KARIM BLVD SURGERY CENTER JSP20-36

Public Hearing at the request of Karim Blvd RE Holdings, LLC for approval of the Preliminary Site Plan, Stormwater Management Plan, and Woodland Use Permit. The subject property contains 3 acres and is located in Section 24, on the west side of Karim Blvd, south of Grand River Ave. The site is currently undeveloped. The applicant is proposing to construct a one-story, 16,941 square foot surgery center, with a two-story 11,412 square foot office for general office use.

PLAN REVIEW CENTER REPORT

Engineering Review of Preliminary Site Plan
Karim Blvd Surgery Center
JSP20-0036

Landscape Plan

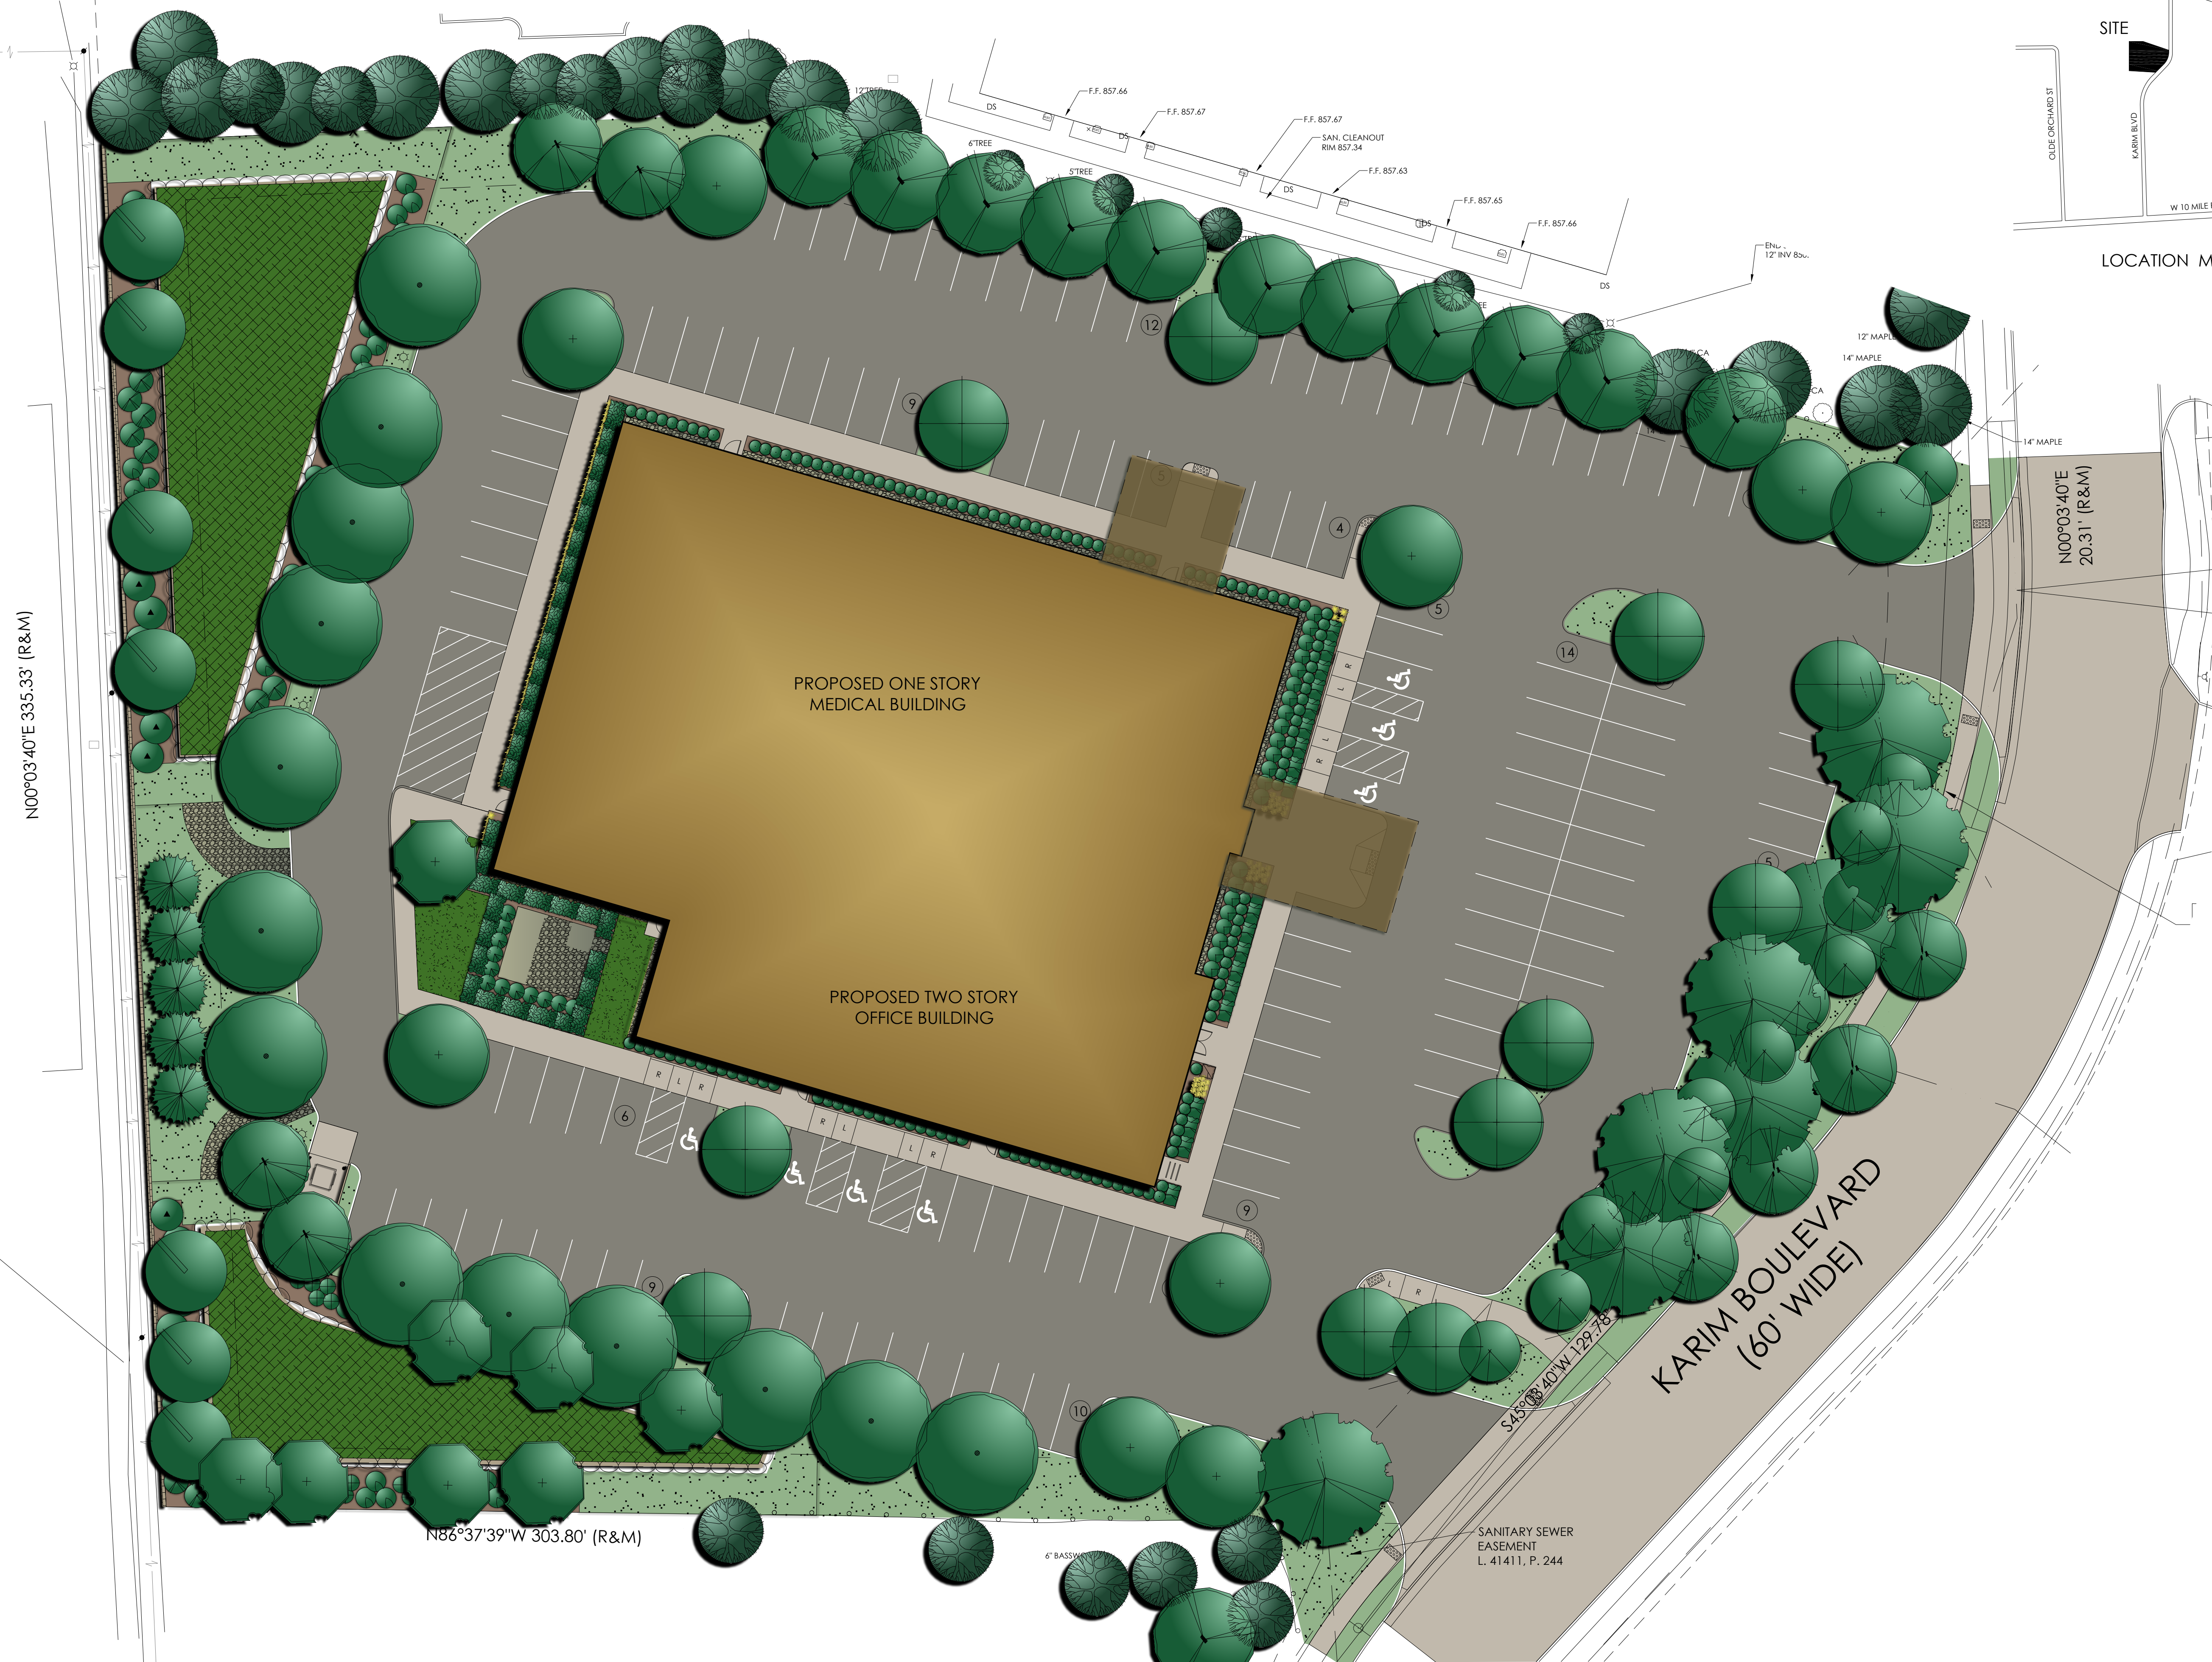
4.5 foot wall proposed as a buffer along the west property line in lieu of the required landscaped berm – *supported by staff as it is consistent with the wall on the property to the south, and additional landscaping around the detention pond will provide additional visual buffering.*

1. All of the existing trees but one is shown as being removed.
2. Four woodland replacements are proposed to be planted on the site as replacement for one regulated 42" dbh tree on the site that will be removed.

1. The required berm is proposed between the entries, but not on the north and south ends of the frontage. **Please provide hedges for those areas to block the view of the parking bays in those areas.**
2. The required greenbelt landscaping is provided.

Sheet Title
Exterior Elevations
 Scale Project Number
 2020.014
 Sheet Number
A2.01

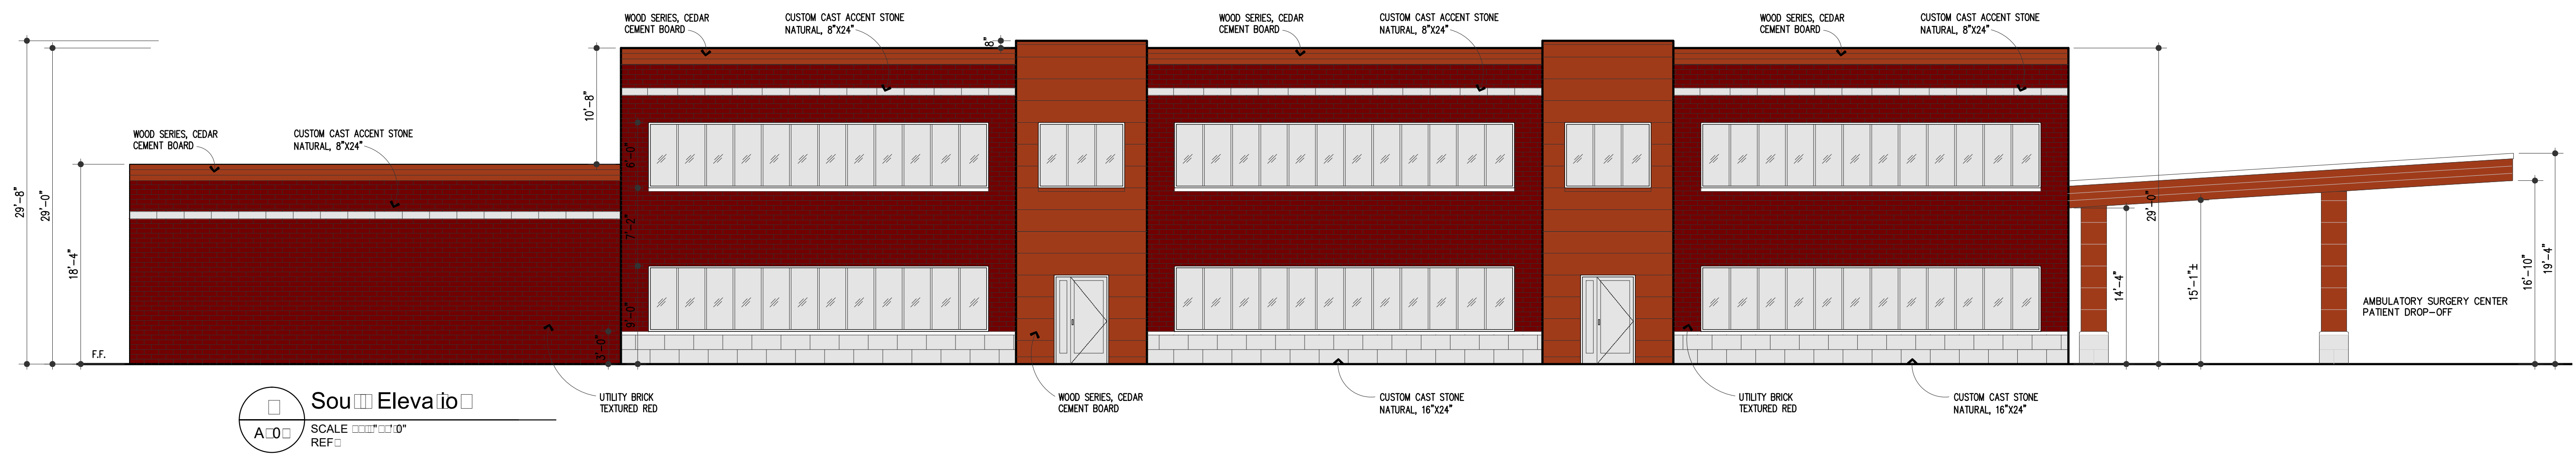
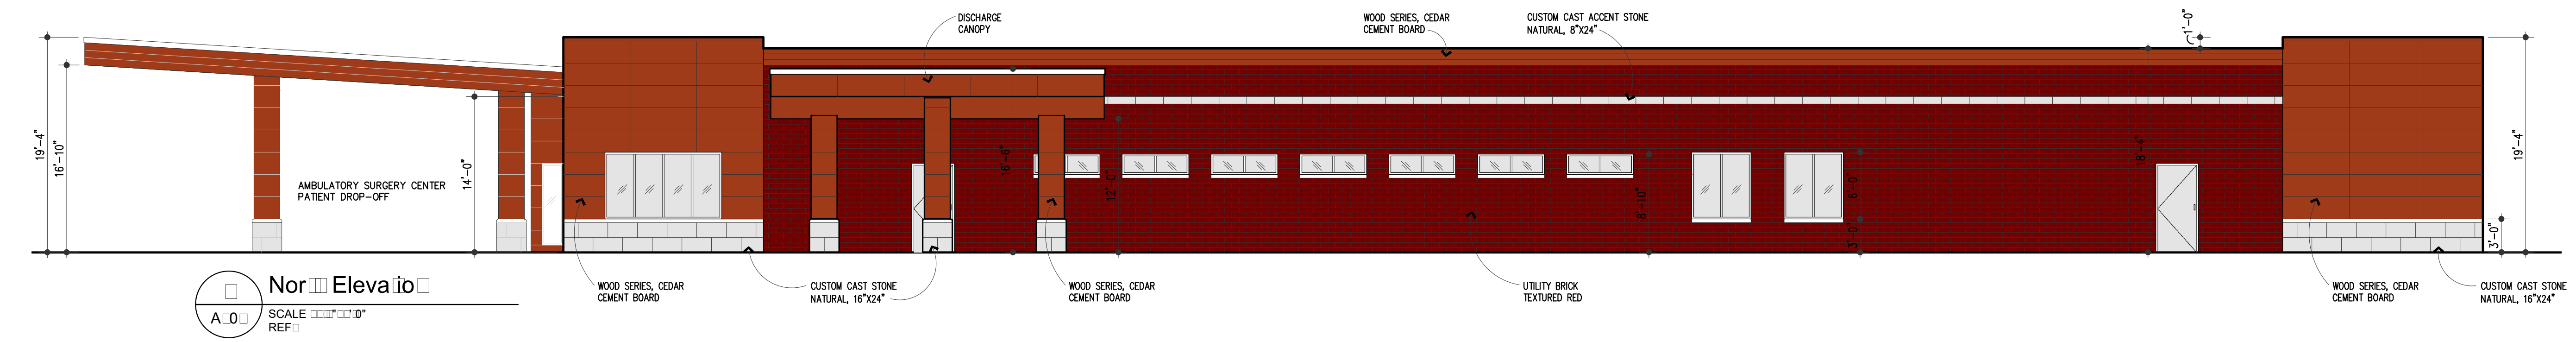
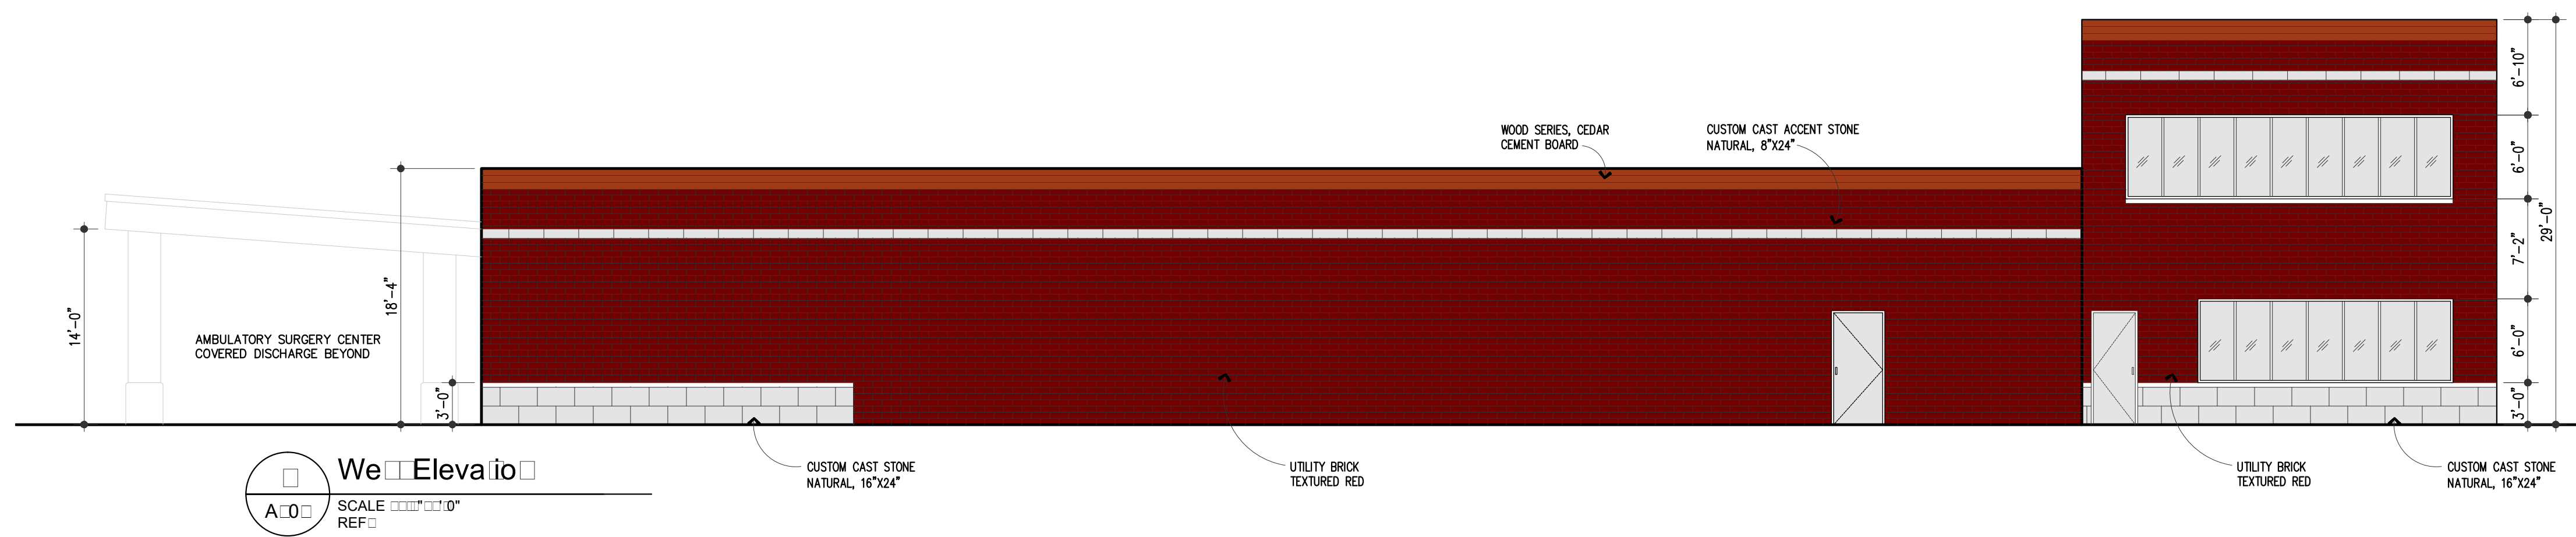
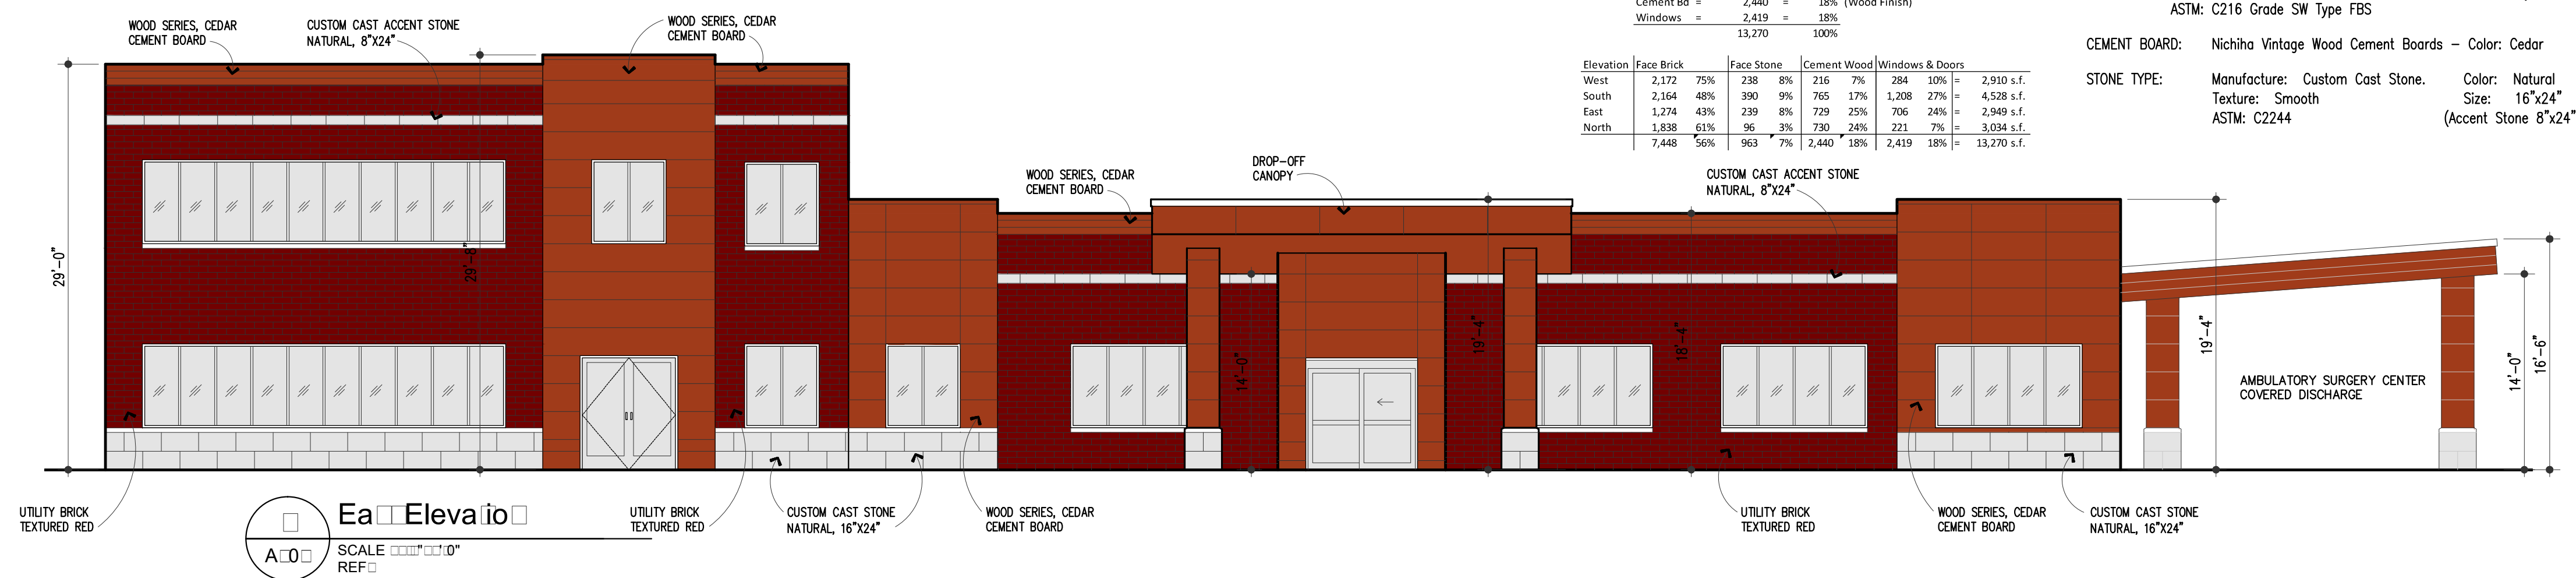
Roof top equipment and wall mounted utility equipment (Sec. 4.19.2.E.ii)	All roof top equipment must be screened, and all wall mounted utility equipment must be enclosed and	Complies?	Yes?	Indicate whether any rooftop equipment is proposed and how it will be screened. Provide height of rooftop equipment. See Façade
